Thank you for the email with a PDF of your Response Reports associated with the Stage 1 Road Safety Audits that we undertook of the proposed pedestrian refuge island along the A4 at Hare Hatch, RSA-25-055-1 and the on-site street layout, ref: RSA-25-069-1.

Project No: ITB21007  
Project Title: Ladds Garden Centre, Bath Road  
Title: Stage 1 Road Safety Audit – GG119 Response Format  
Ref: TW/BB/ITB210007-004 TN  
Date: 2 July 2025

## **Proposed Pedestrian Refuge Island along the A4 Bath Road Hare Hatch**

| DRAWING No:<br><b>ITB210007-GA-004</b>  |                      |                       |   | REV:<br>B |          |

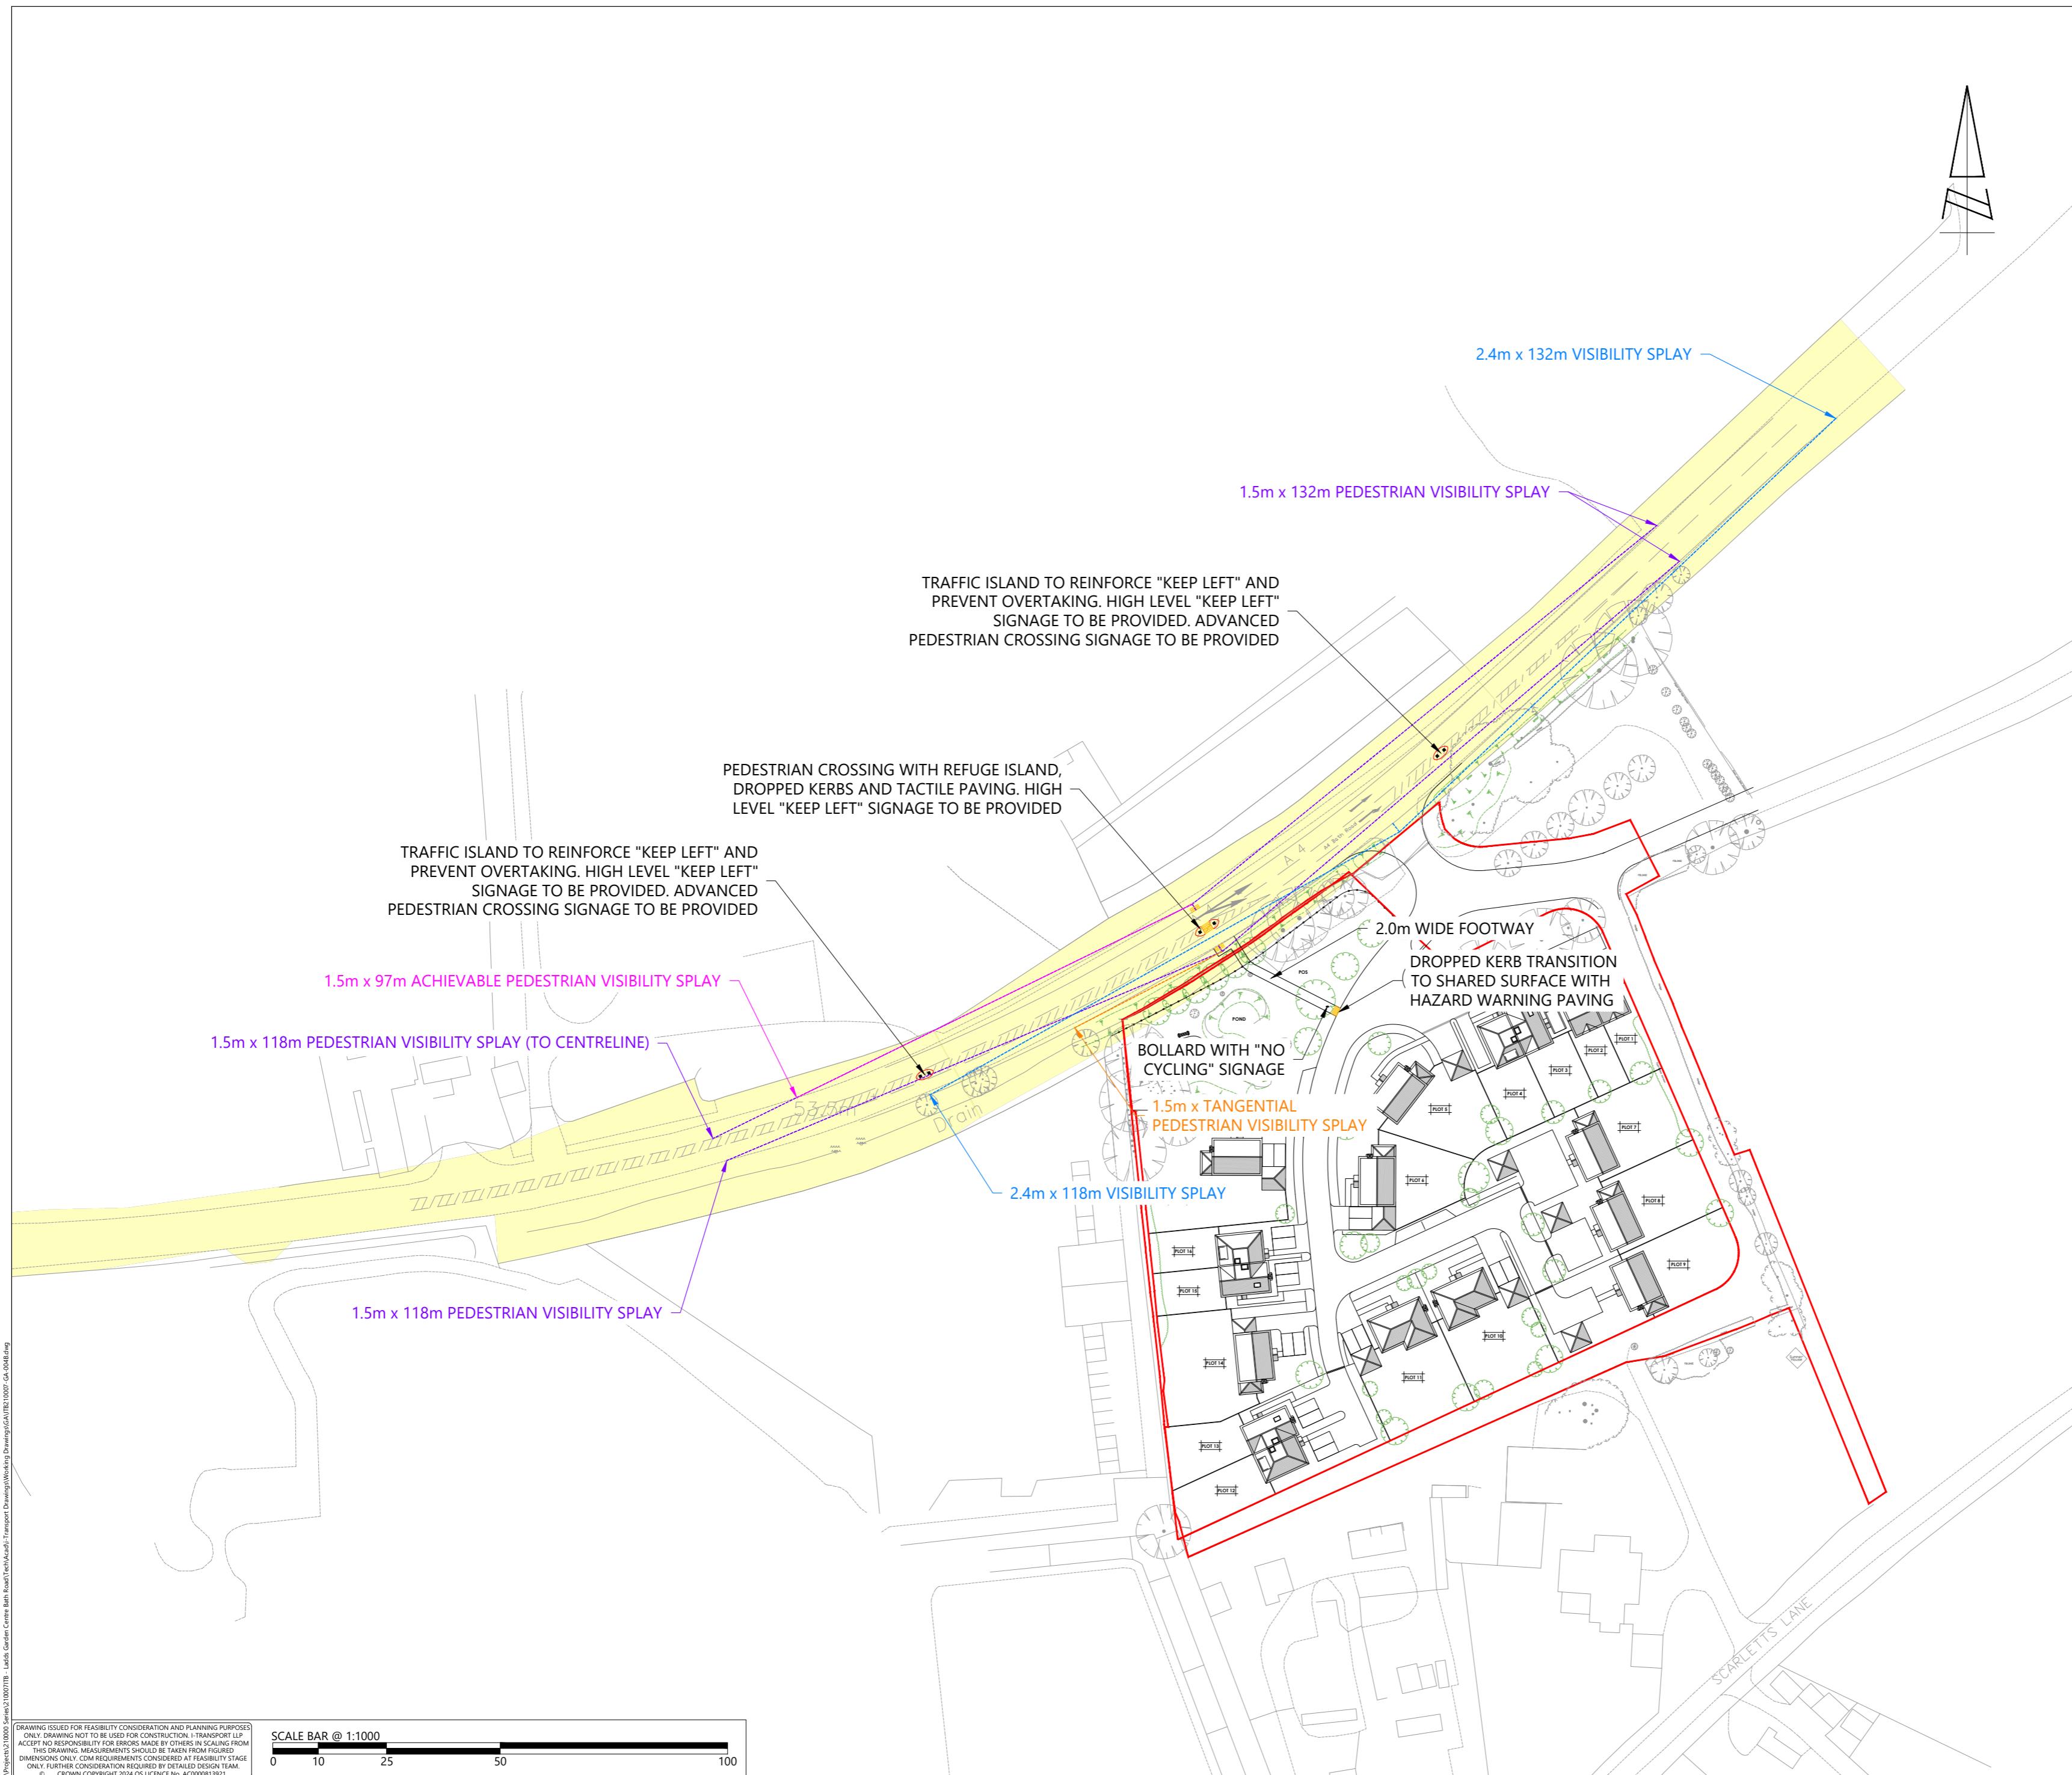
| RSA Problem  | RSA Recommendation   | Design Organisation Response  | Overseeing Organisation Response | Agreed RSA Action |
|--|--|---|----------------------------------|-------------------|
| <p><b>2:</b> The scheme proposals include the provision of a footpath link that is to connect between the proposed redevelopment and a proposed uncontrolled crossing point along the A4 Bath Road which is to facilitate pedestrian access to and from the existing footway to the north. The proposed uncontrolled crossing point is to accommodate tactile paving to warn pedestrians of the live carriageway, however, it is noted that no measures are provided to highlight the change in route characteristics where the proposed footpath meets the on-site shared surface street. The Audit Team have concerns that a pedestrian may enter the on-site carriageway unaware of the potential for vehicular and cyclist traffic which could lead to a vehicle / cyclist to pedestrian type collision.</p> | <p>It is recommended that appropriate measures are provided to highlight the transition between the proposed footpath and shared surface area.</p> | <p>Accepted – the design has been amended to provide corduroy hazard warning paving at the transition between the proposed footpath and the shared surface street. This will clearly highlight the transition to all users. The revised arrangements are shown on drawing no. <b>ITB210007-GA-004B</b>.</p> | <p>-</p>                         | <p>-</p>          |

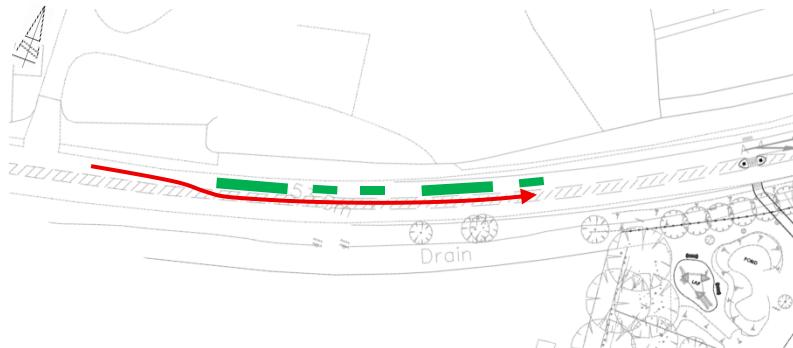
| <b>A.2</b>  |  | <b>GENERAL</b> |  |  |
|---|--|----------------|--|--|
| <p>The A4 Bath Road is subject to a 40mph speed limit within the village of Hare Hatch where a number right turn lanes are accommodated to allow access to amenities and properties off both sides of the carriageway. Those right turn lanes are separated by areas of central hatching to form consistent eastbound and westbound lane widths. The carriageway follows a bend towards</p>   |  |                |  |  |

the eastern end of the village where the speed limit of the road changes from 40mph to 50mph, circa 160 metres to the west of the priority access and just circa 115 metres before the right turn lane associated with Ladds Garden Village. The proposals include the provision of an uncontrolled crossing point immediately to the west of the right turn lane associated with the Ladds Garden Village. Measurements have been taken from the scheme drawing and it has been determined that an eastbound motorist should be able to see the proposed refuge island from a point 139 metres in advance of the feature provided vegetation is cleared and maintained as indicated. This distance exceeds the stopping sight distance of a vehicle travelling at the 85<sup>th</sup> percentile speed recorded as well as that associated with the 40mph speed limit at that location. The Audit Team have concerns, however, that eastbound motorists may attempt to utilise the existing central hatched area to overtake slow moving vehicles and that the physical island will not be clearly visible due to its proposed location, around a left hand bend. Motorists not becoming aware of the proposed physical island at a safe distance could collide with the physical island leading to a vehicle to pedestrian or loss of control type collision.

It is recommended that a series of physical islands are provided within the central hatching along the A4 Bath Road within Hare Hatch and extending to the proposed refuge island.

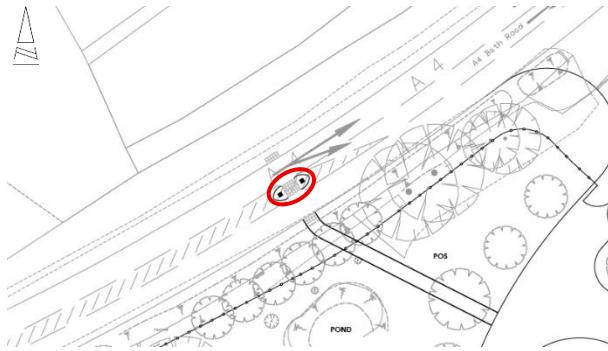
| A.2.3   | PROBLEM  |
|---|--|
| <p>The A4 Bath Road observes a high percentage of HGV's as well as other high sided vehicles and accommodates a number of traffic islands that benefit from keep left bollards as well as illuminated high level signs. The proposals include the provision of an uncontrolled crossing point that benefits from a refuge island. The scheme drawings illustrate that keep left bollards are to be installed on the physical islands, however, no high level signage is proposed. The Audit Team have concerns that motorists following high sided vehicles will not become aware of the proposed physical island</p> |  |

at a safe distance and may attempt to overtake which could lead to a vehicle colliding with the island and a loss of control type collisions.

It is recommended that illuminated high-level keep left signage is provided.

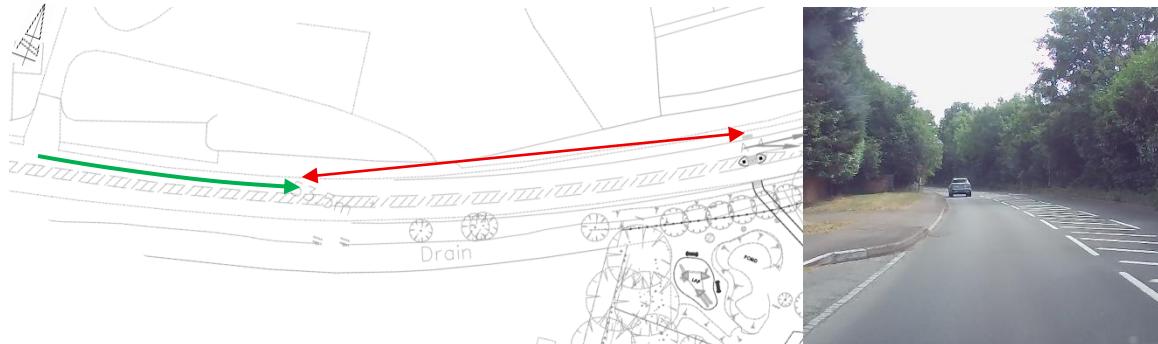
The A4 Bath Road that is subject to street lighting in proximity to the village of Hare Hatch where a 40mph speed limit is present which increases to 50mph for eastbound traffic, at a point circa 160 metres to the west of the priority access and 115 metres before the right turn lane associated with Ladds Garden Village. The characteristics of the A4 Bath Road appear to change at the existing change in speed limit becoming more rural in nature with foliage both sides of the carriageway. The proposals include the provision of an uncontrolled crossing point immediately to the west of the existing right turn lane associated with the Ladds Garden Village, at a location immediately adjacent to an existing street lighting column. The scheme drawing illustrates that visibility slays in accordance with 85<sup>th</sup> percentile speeds are achievable from each crossing point, however, the 118 metre splay to the west of the northern uncontrolled crossing point extends to the road centreline rather than the channel line. It is noted that a splay of 97 metres is achievable to the channel line. The Audit Brief identifies that all visibility splays are to be cleared and maintained clear of obstructions and that the 118 metre splay to the road centre line represents a Departure from Standard (DfS), as the splay should extend to the nearside channel line. The proposed uncontrolled crossing benefits from a refuge and therefore users cross each 3.5 metre lane individually. As stated within Chapter 6 of Traffic Signs Manual, a lower walking speed of 1.0m/s is utilised to calculate timings for crossings which when applied to the lane width, would

mean that a pedestrian is expected to be within the carriageway for 3.5 seconds. This is increased to 4.4 seconds when based on UCL research which identified that the average walking pace of an elderly pedestrian aged over 65 is 0.8m/s. It can be determined that an eastbound vehicle approaching the proposed uncontrolled crossing at the 85<sup>th</sup> percentile speed observed of 43.9mph, will take 5 seconds to travel the 97 metres. It is therefore clear that, provided the visibility splays illustrated are maintained clear, a pedestrian should have an adequate level of visibility to cross the 3.5 metre eastbound lane based on 85<sup>th</sup> percentile approach speed. It is noted, however, that traffic could legally travel at speeds in excess of the 85<sup>th</sup> percentile speed recorded which would render the achievable level of visibility insufficient. An eastbound motorist approaching a pedestrian who is crossing the eastbound lane will have clear visibility of the pedestrian within the carriageway ahead even during the hours of darkness, due to the presence of street lighting column, and should therefore adjust their speed accordingly. The Audit Team have concerns, however, that the route characteristics of the A4 Bath Road are to remain unchanged and rural in nature. Eastbound motorists are unlikely to expect a pedestrian to cross the carriageway at this location which could lead to heavy braking and loss of control type collisions.

It is recommended that appropriate warning signs are provided.
